Addendum No. 03

June 9, 2026

Parlier HS Stadium Replacement

PBK PROJECT NO.: 250093
DSA FILE NO.: 10-H12
DSA APPLICATION NO.: 02-124002 _ PARLIER HS STADIUM REPLACEMENT

PARTIAL DEMOLITION PLAN
CS2.2

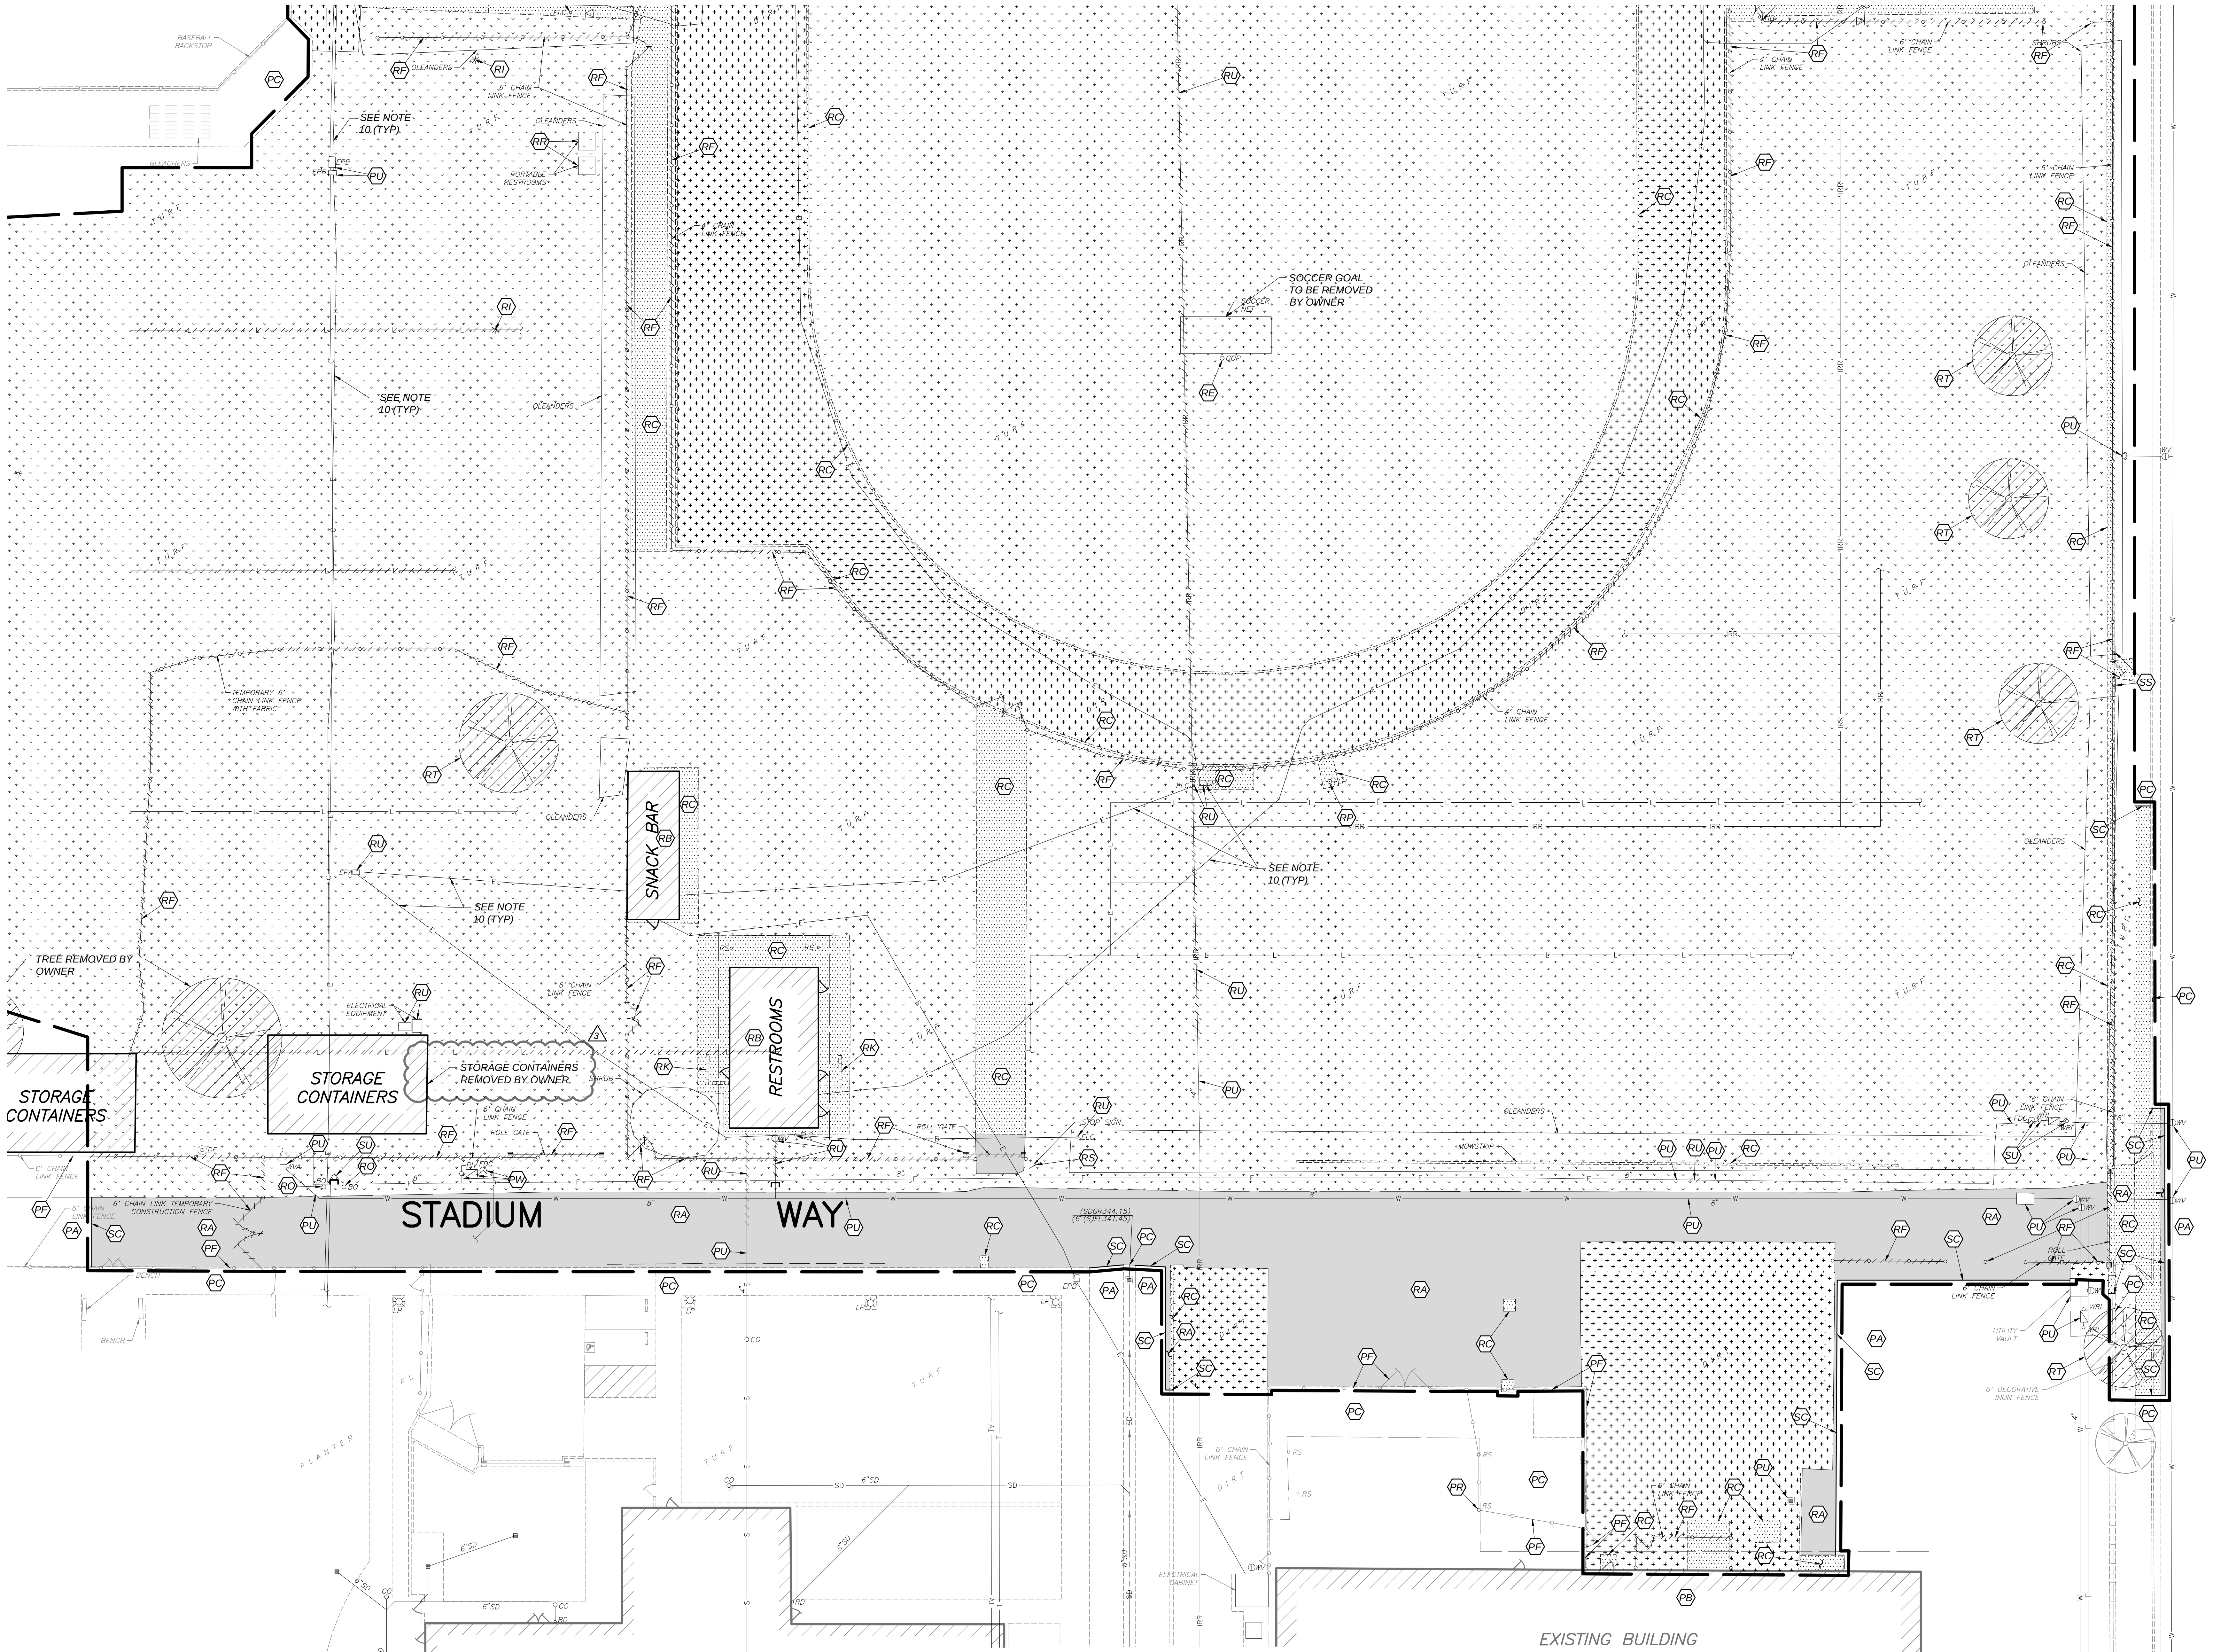
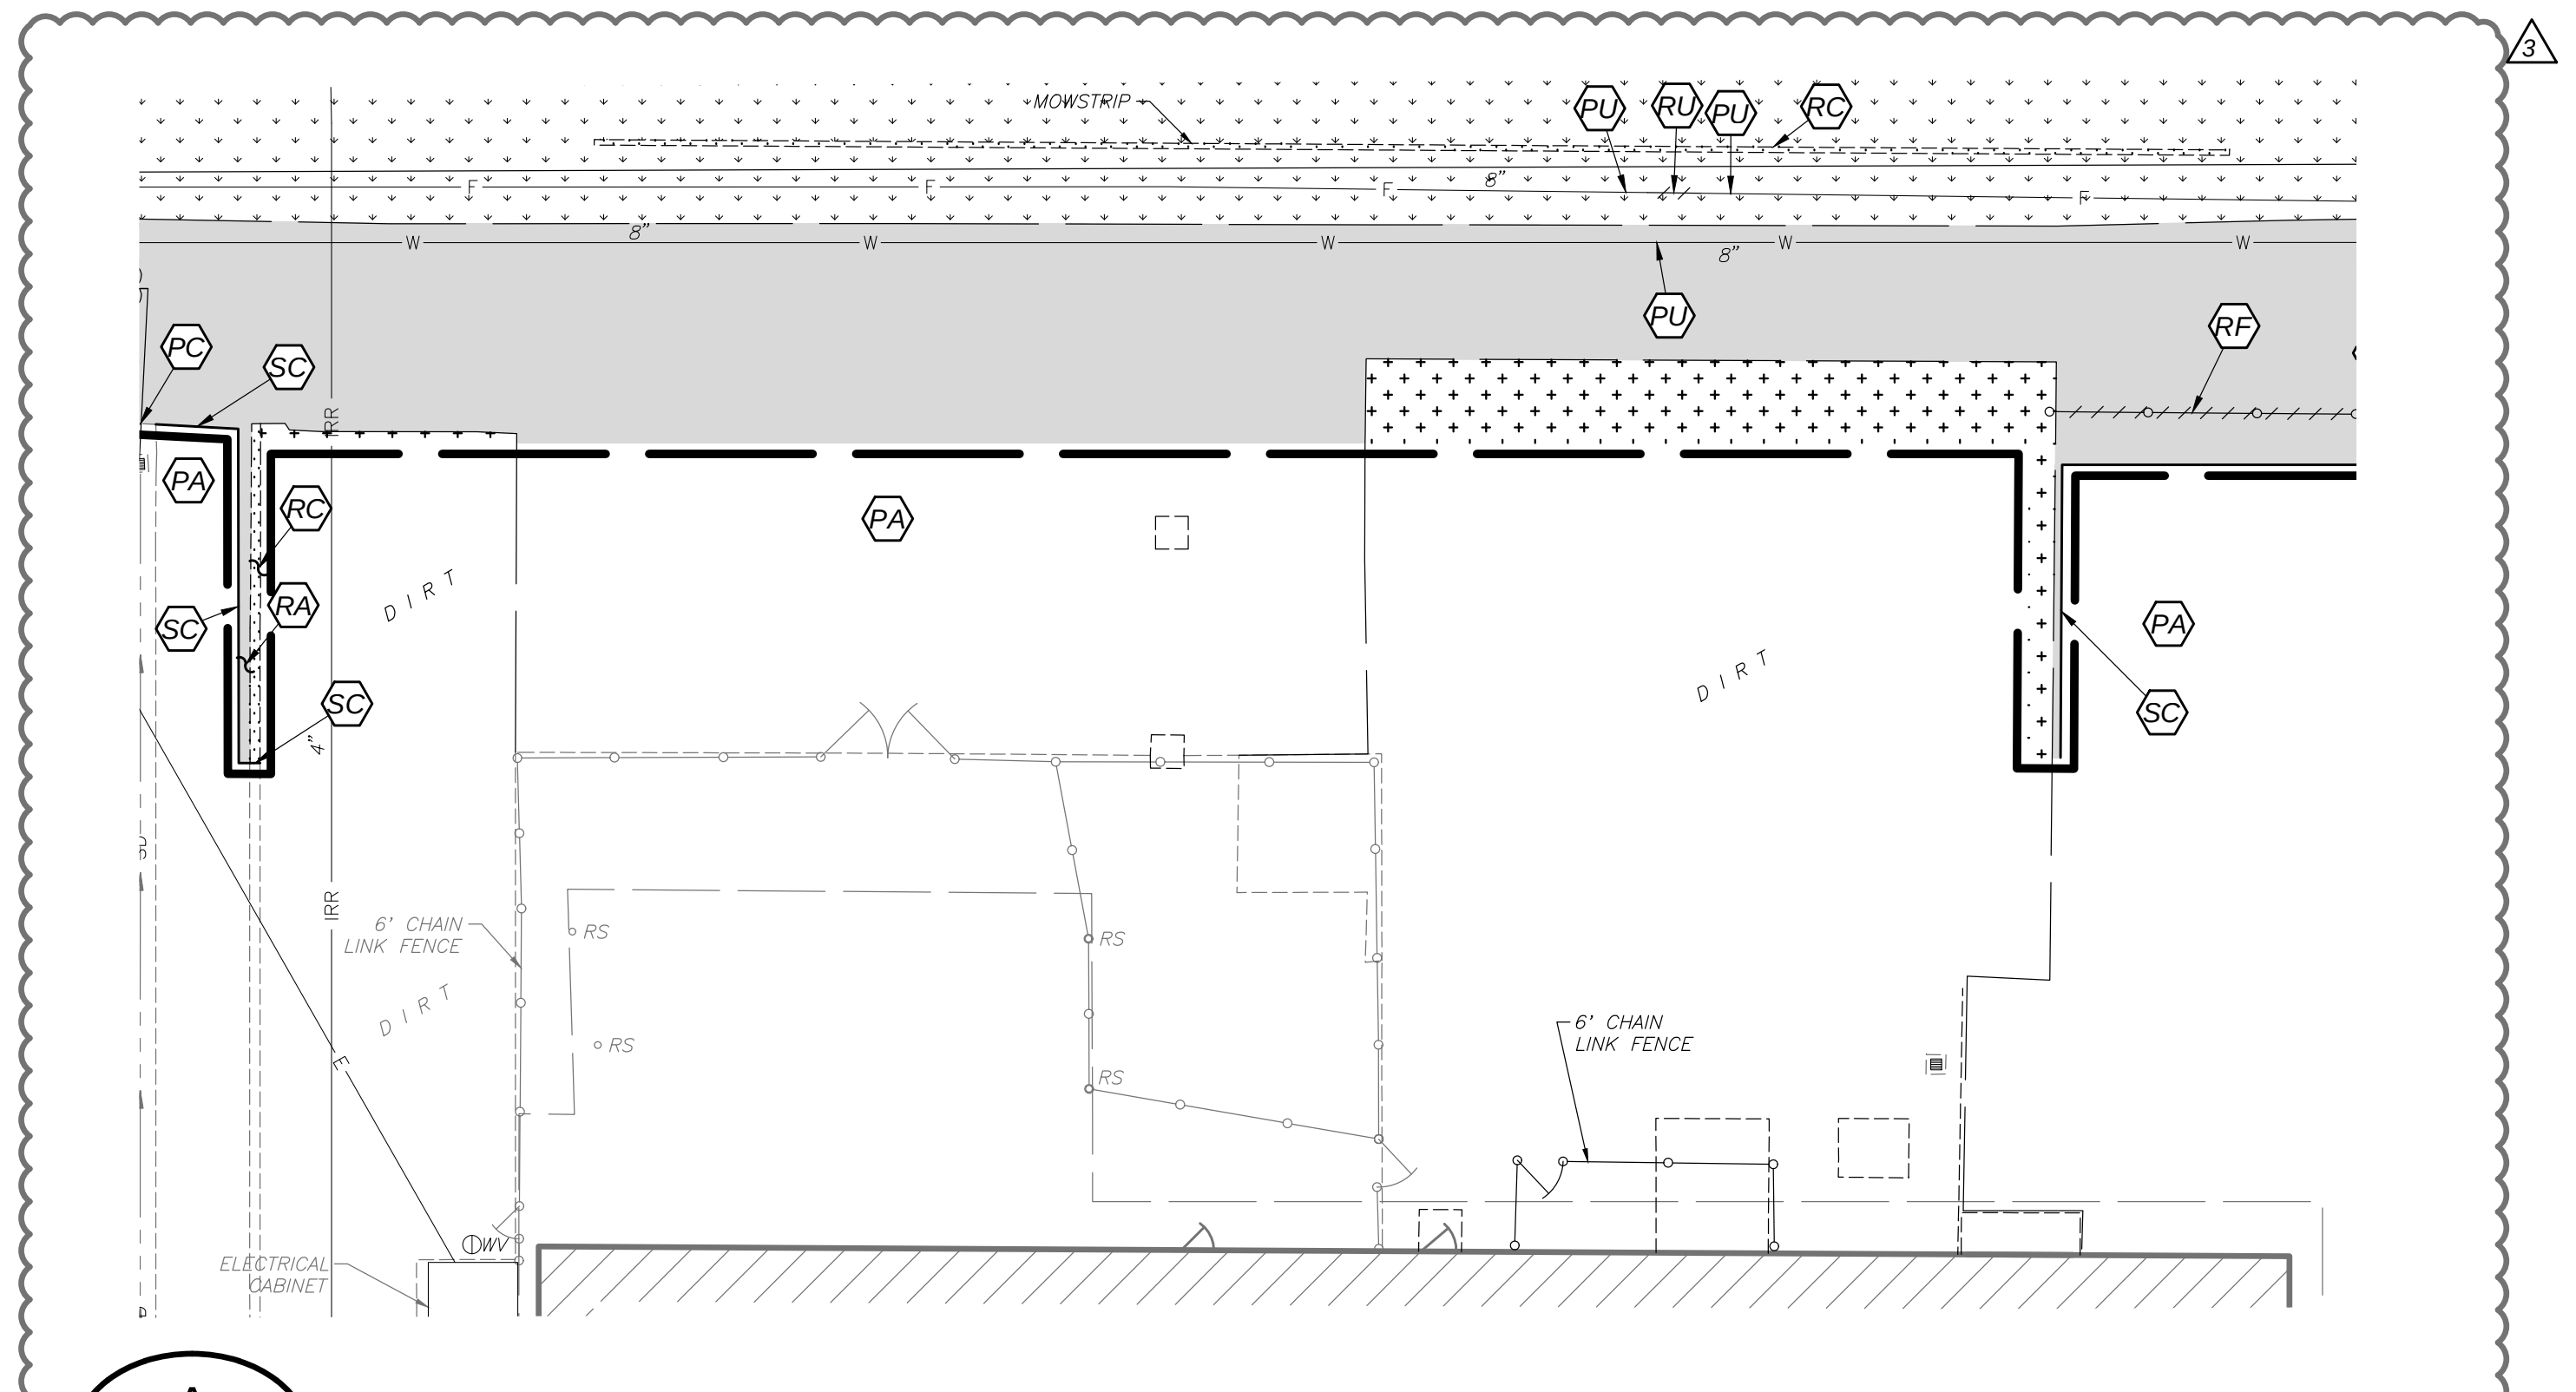
2. Refer to sheet CS2.2 “PARTIAL DEMOLITION PLAN”
    a. Remove and replace sheet CS2.2 “PARTIAL DEMOLITION PLAN” with herein attached sheet CS2.2 “PARTIAL DEMOLITION PLAN” identified with AD3 on the bottom right-hand corner.

- Revised legend and added callouts.
- Added Alternative Deduction 6

A
CS2.2
ADD ALTERNATIVE DEDUCTION 6
1" = 20'

PARTIAL DEMOLITION PLAN
CS2.3

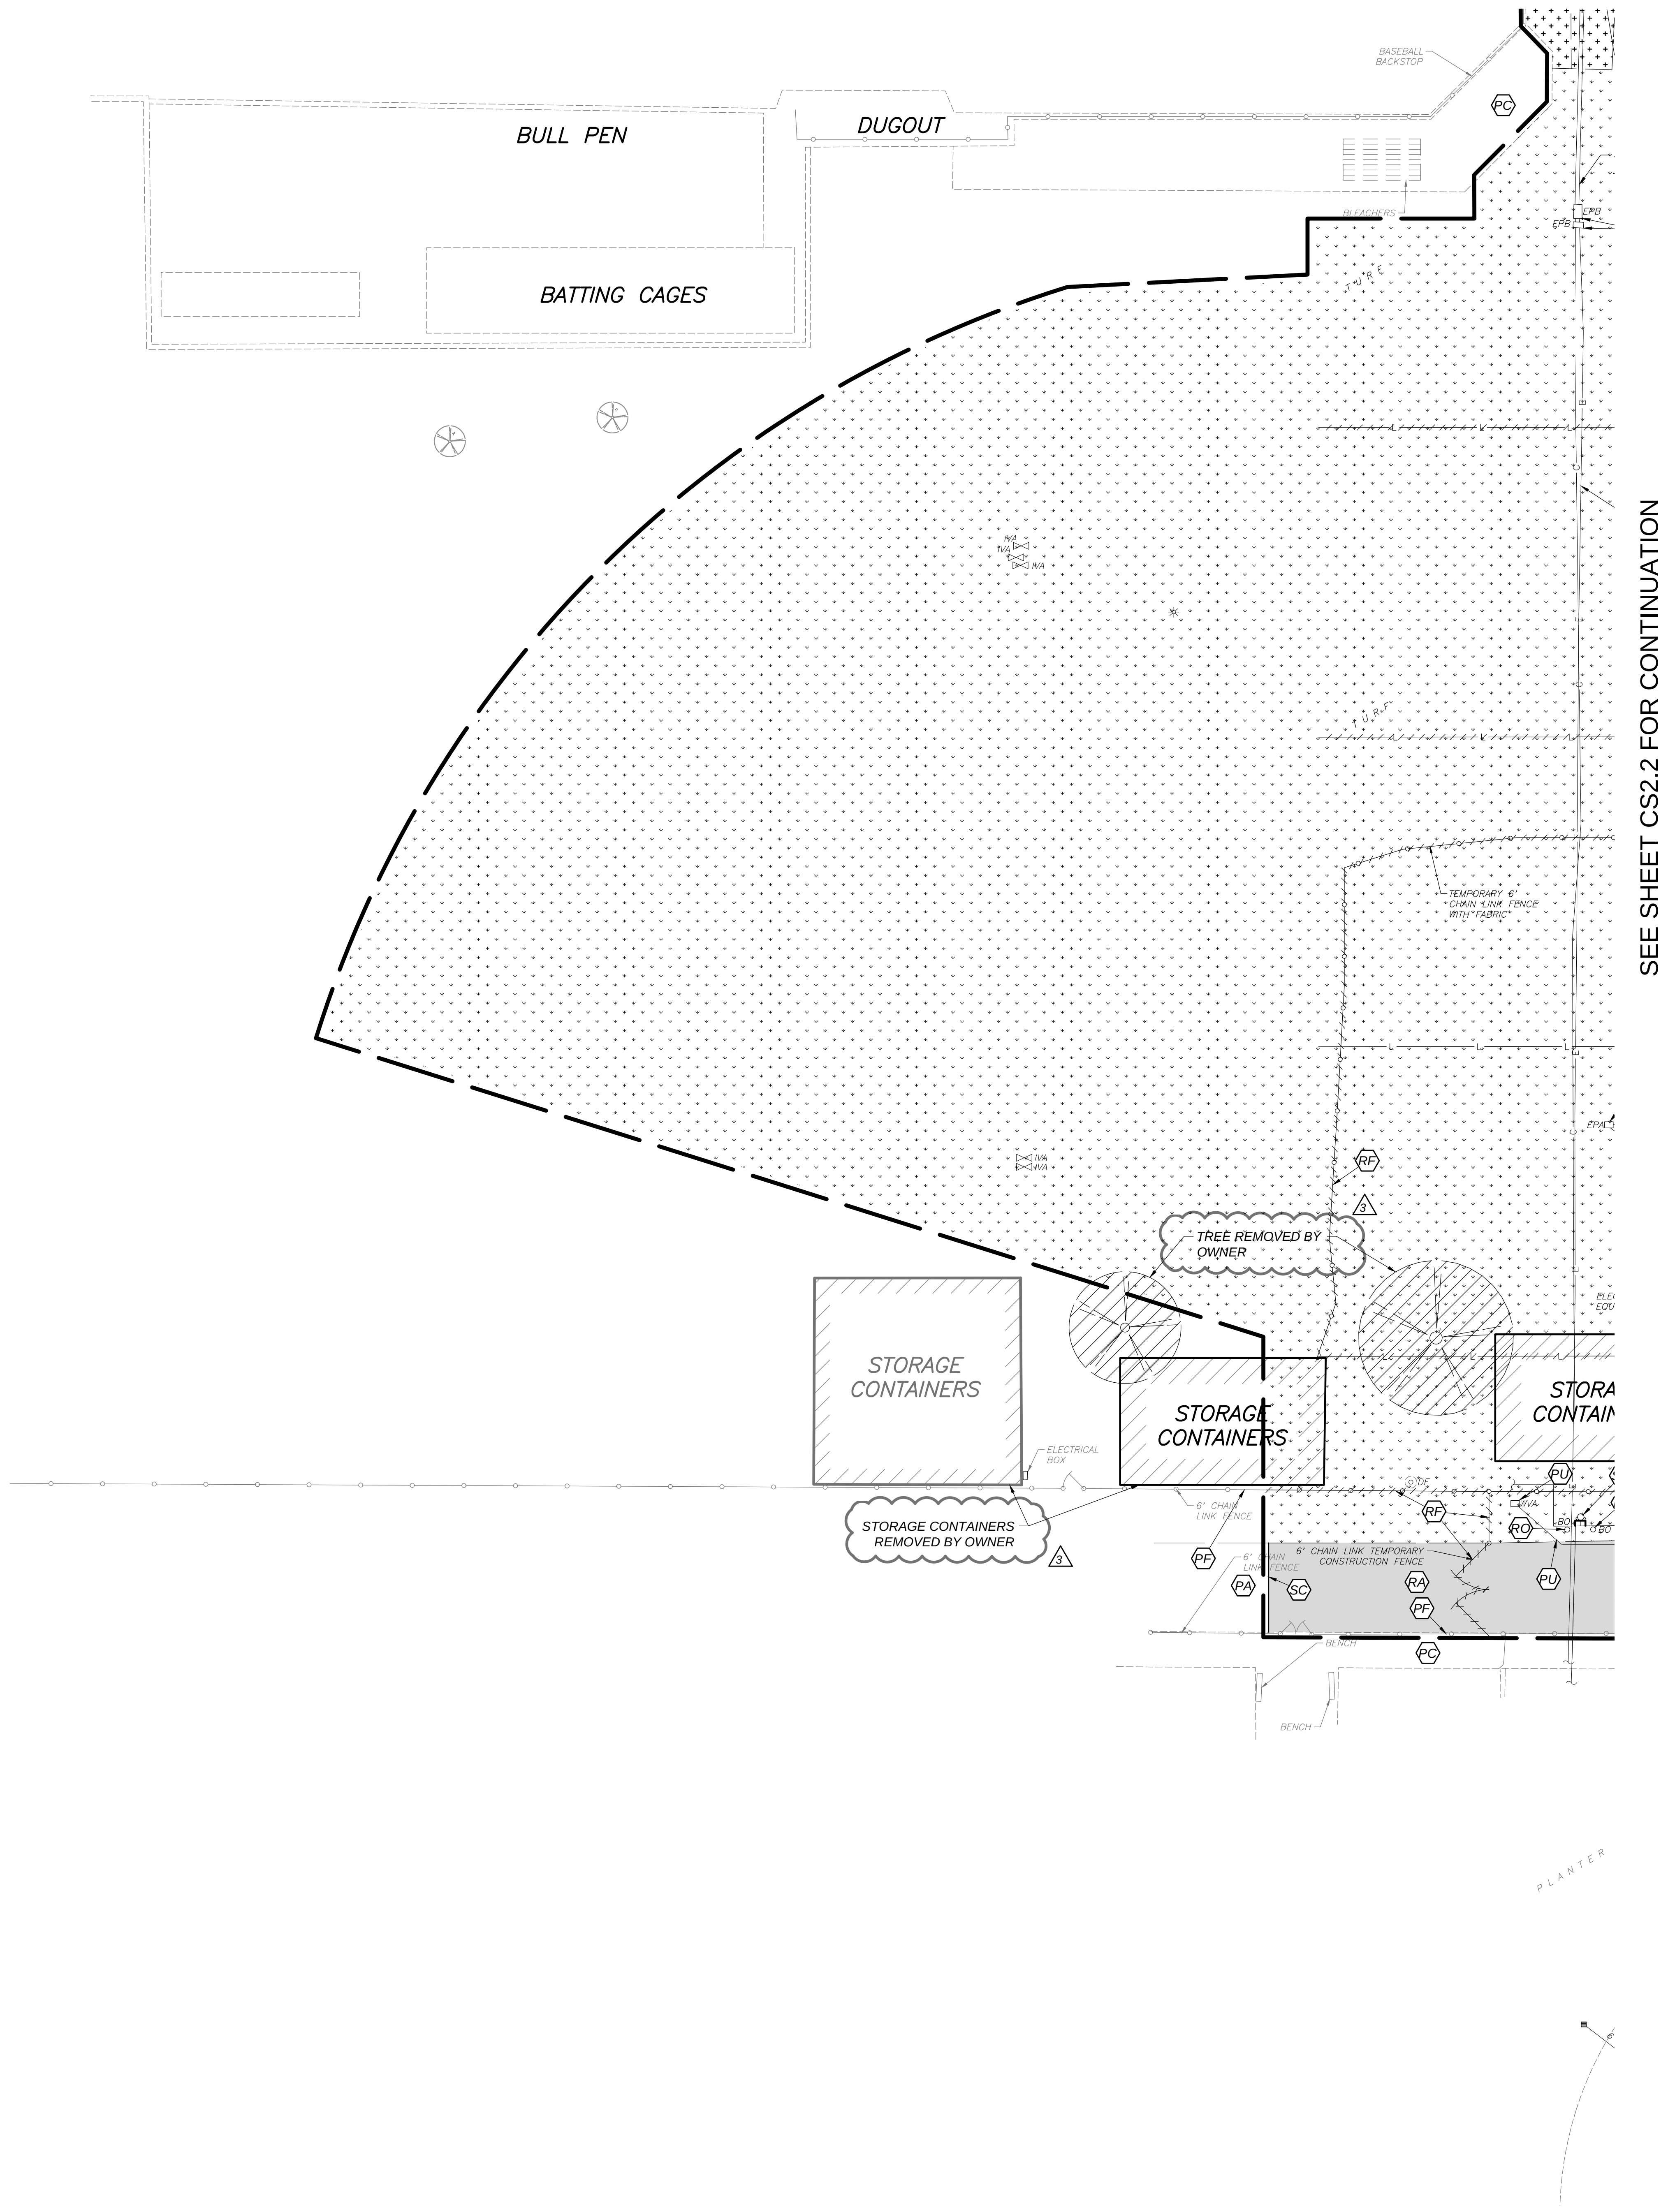
3. Refer to sheet CS2.3 “PARTIAL DEMOLITION PLAN”
    a. Remove and replace sheet CS2.3 “PARTIAL DEMOLITION PLAN” with herein attached sheet CS2.3 “PARTIAL DEMOLITION PLAN” identified with AD3 on the bottom right-hand corner.
